Your Ref : MCU/2018/58

RFI RESPONSE MCU/2018/58
202 BAILEYS MOUNTAIN ROAD, UPPER COOMERA (LOT 58 SP191940)

On behalf of our client, Sandson Pty Ltd (the applicant), we hereby provide the following full response to Council's information request dated 9th March 2020.

Project	202 BAILEYS MOUNTAIN ROAD, UPPER COOMERA
Title	PRELIMINARY EARTHWORKS CONVEYANCE CHANNEL LAYOUT PLAN

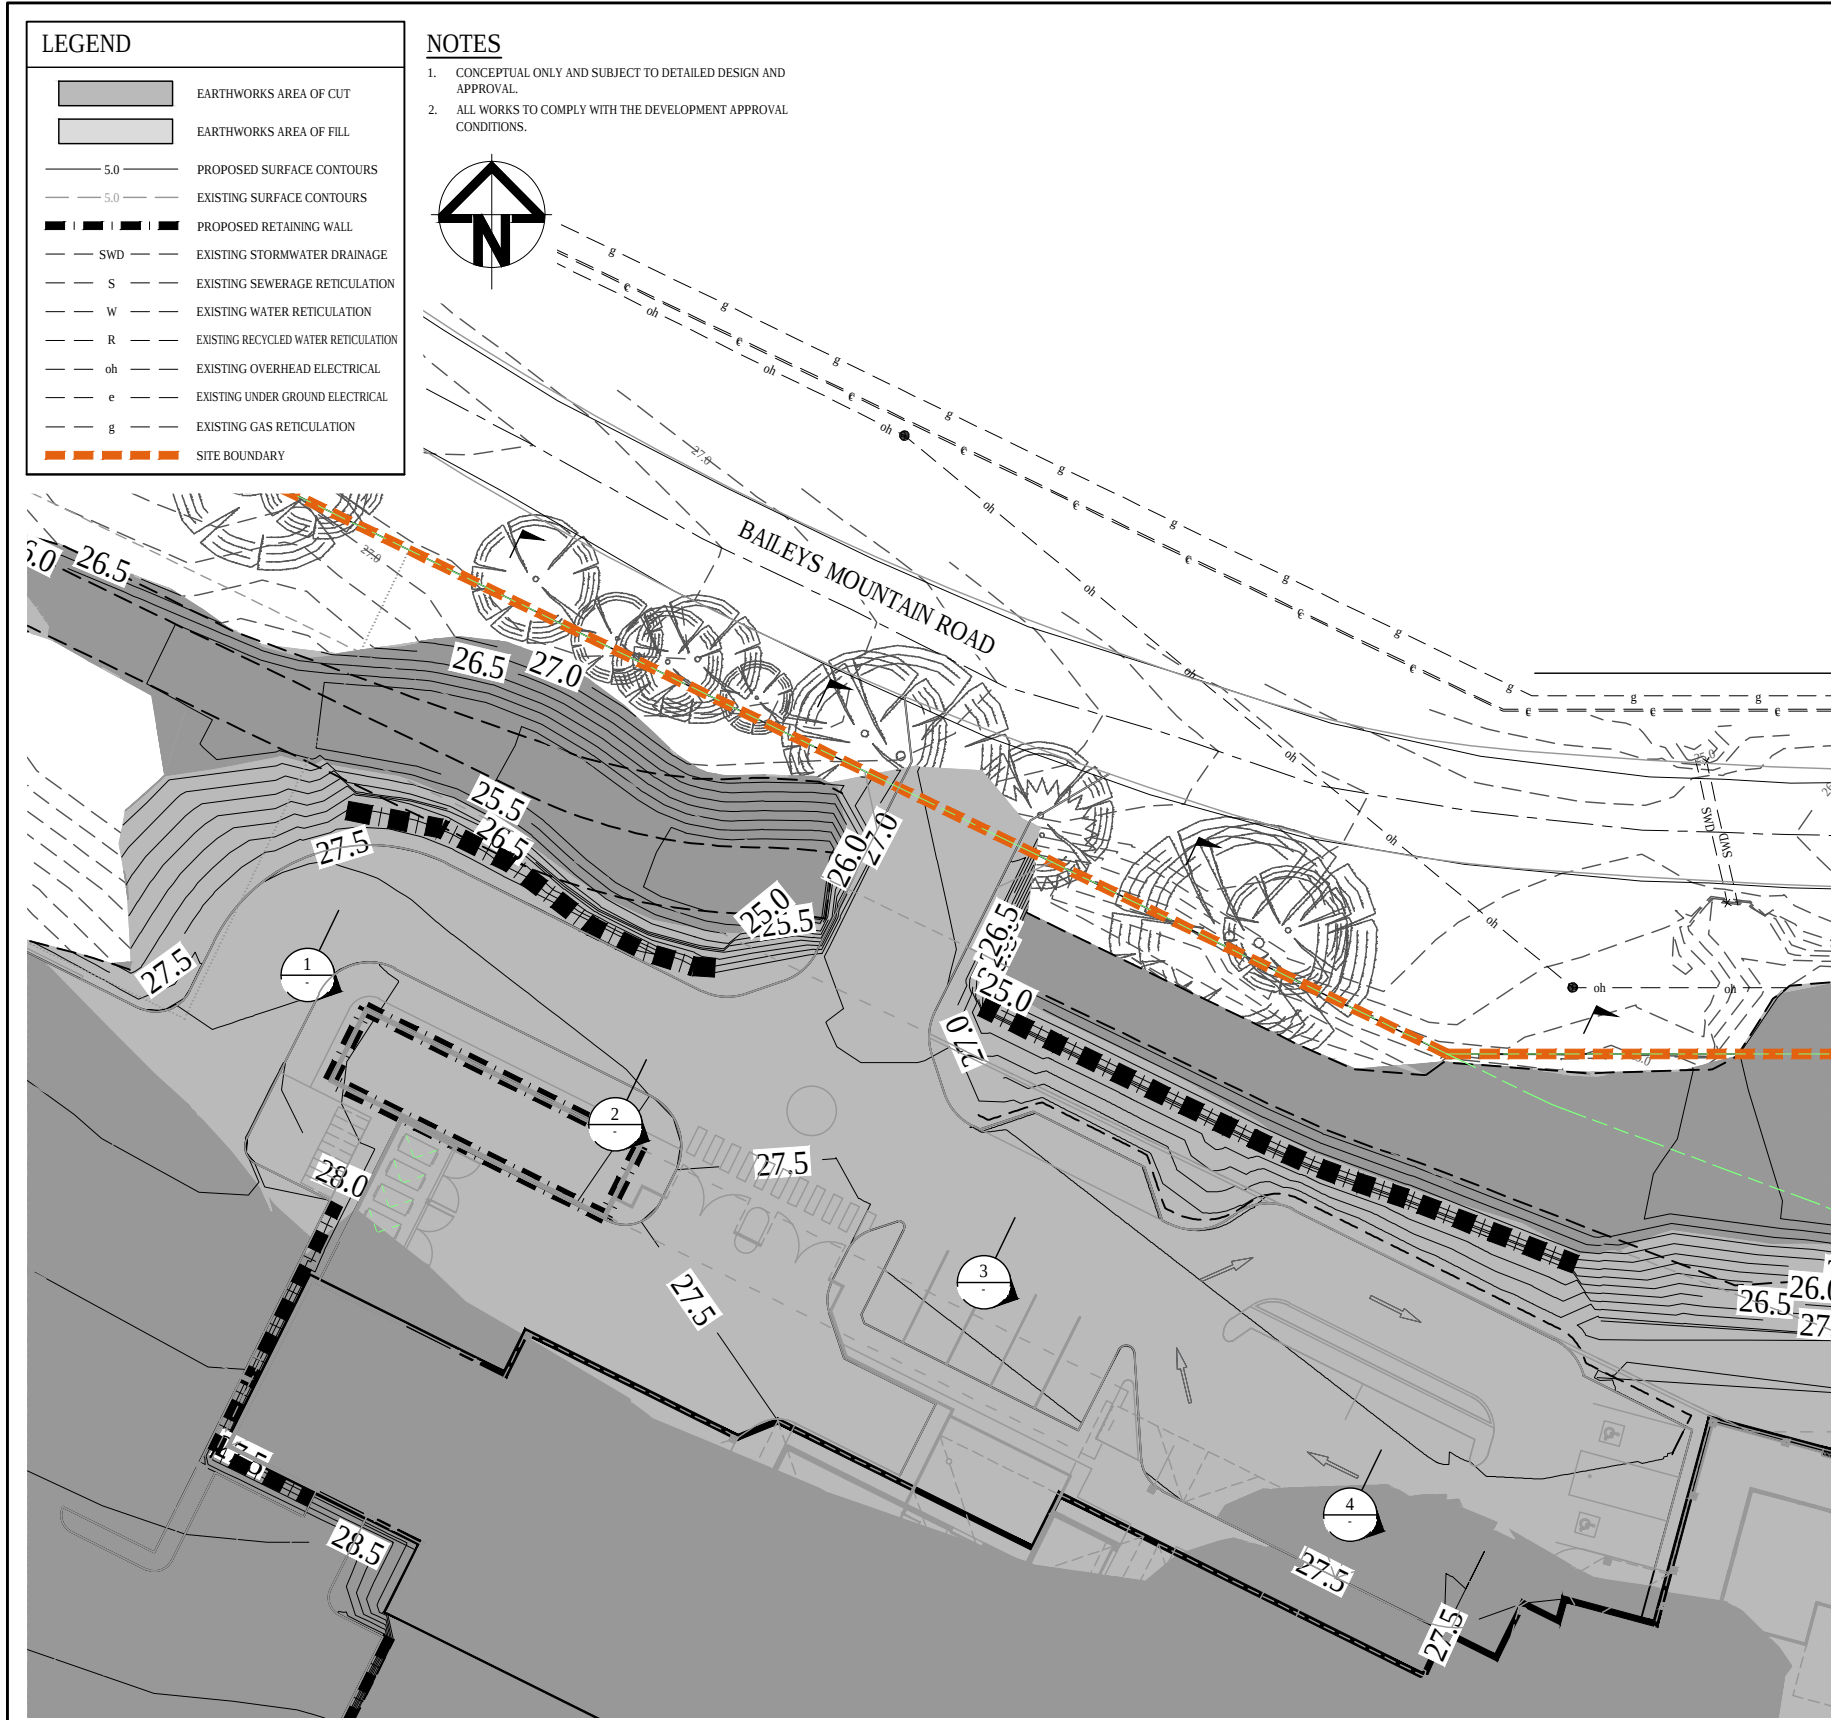
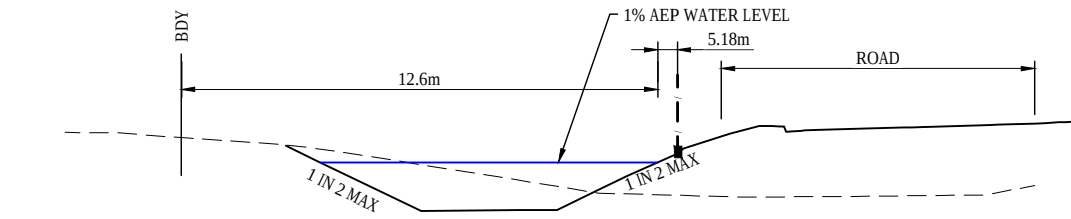
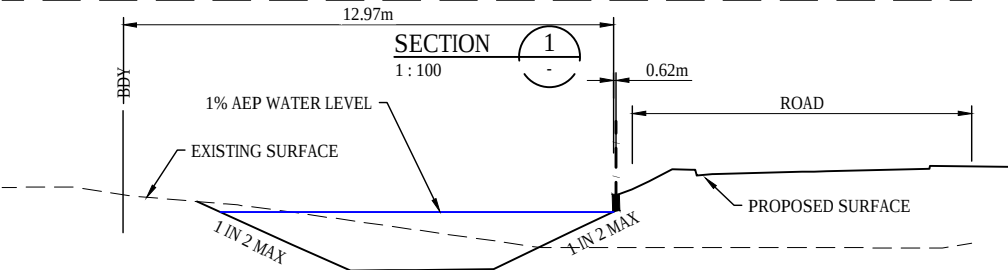
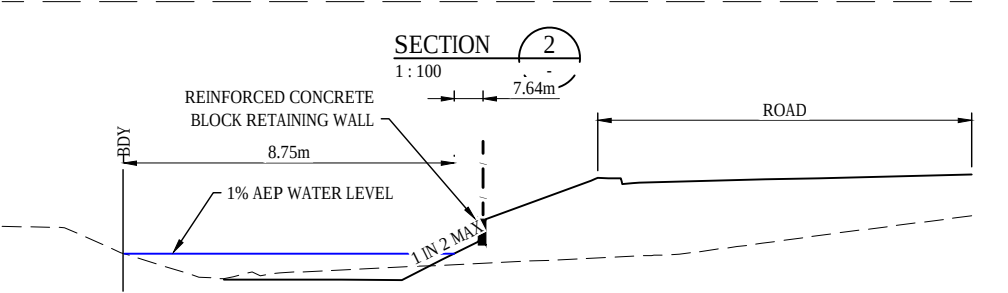
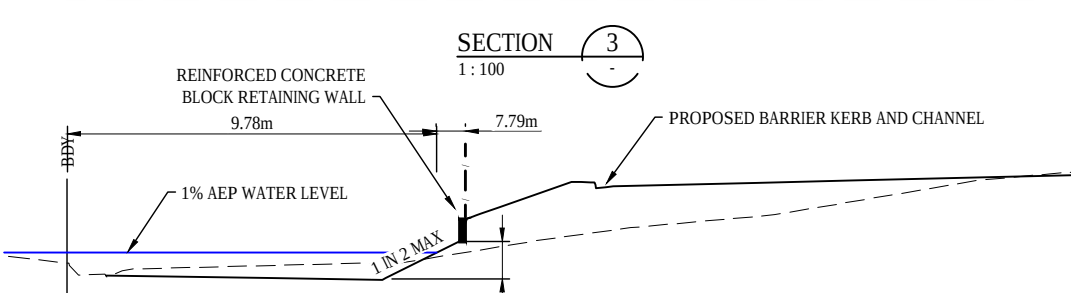
- b) Provide earthworks cut and fill plan associated with representative cross-sections along the overland flow paths clearly showing the retaining walls and other structures. Officers consider that the overland flow corridor along Baileys Mountain Road needs to be dedicated as a drainage reserve; the western and southern conveyance channels need to be dedicated as drainage easement; and the eastern Yaun Creek corridor needs to be dedicated as environmental buffer and open space for pedestrian linkage. In this regard, please clearly identify the widths of these drainage corridors for appropriate conditioning purposes. Please also note that retaining walls are to be located a minimum 600mm from the edge of (outside of) the drainage reserve and drainage easements.

Note: The impact analysis plan (Dwg No. 19111/CD-09/DA1) indicated two dimensions (being 6m and 3m) for the southern conveyance channel, while the proposed site plan (Dwg No. 19111/CD-01/DA1) indicates it to be 6m. Please provide consistent information throughout the submission.

Sk005, Attachment 1, has been updated to include cross-sections along the overland flow path adjacent to the development's entry driveway. Refer to response below for item c) for details pertaining to the width of conveyance channels along the western and southern boundaries.

UPSTREAM CROSS SECTION OF DRIVEWAY CROSSING DURING 100% BLOCKAGE EVENT

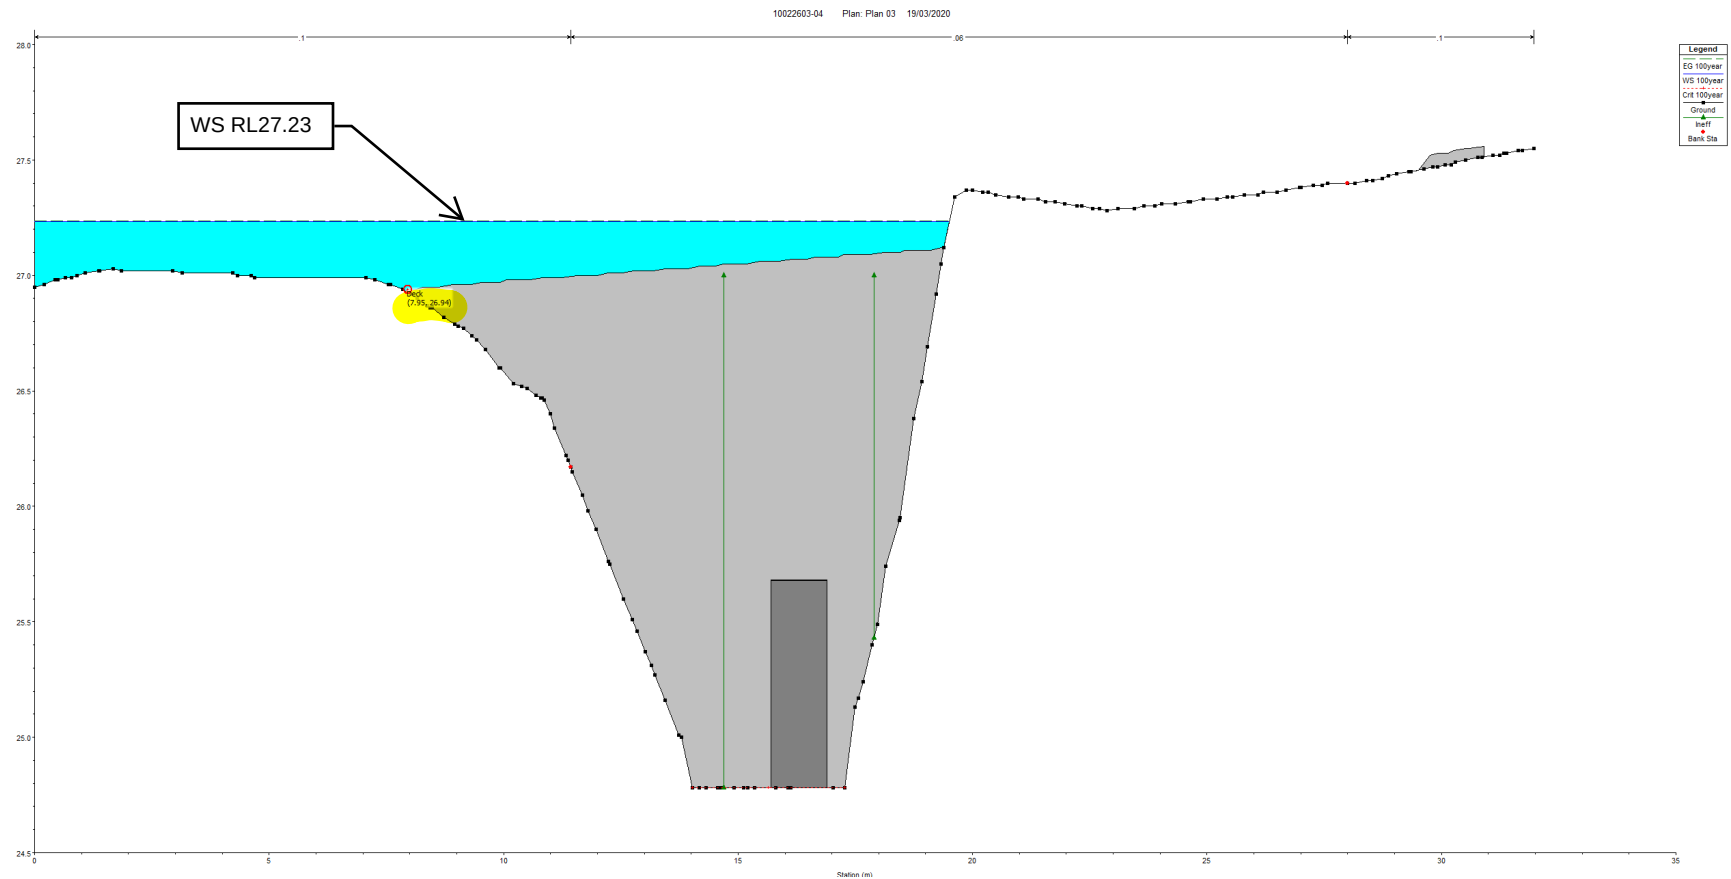
- d) For any overflow on top of the proposed driveway, the applicant is requested to demonstrate that the depth of inundation (d) and depth product velocity ($d \cdot v$) will satisfy the flood safety requirements as per QUDM (e.g., $d \leq 250\text{mm}$, $d \cdot v \leq 0.25\text{m}^2/\text{s}$) by considering necessary blockage of the culverts. Please also undertake a sensitivity analyses of the driveway flood safety hazards by considering 100% blockage of the cross-drainage structure.

A sensitivity check has been undertaken for 100% blockage of the culvert system based on a severe storm as recommended by QUDM. The depth of flow over the driveways is 0.31m and the velocity is 0.17m/s during a 100% blockage event. This results in a depth velocity product of $0.05\text{m}^2/\text{s}$ during a severe storm. This is considered a low degree of hazard in accordance with Table 8.2.8-5 of Part 8 of the City Plan. It should be noted that a severe storm check is for sensitivity only and not for design. Please refer to Attachment 2 for a cross section of upstream of access driveway during a 100% blockage event.
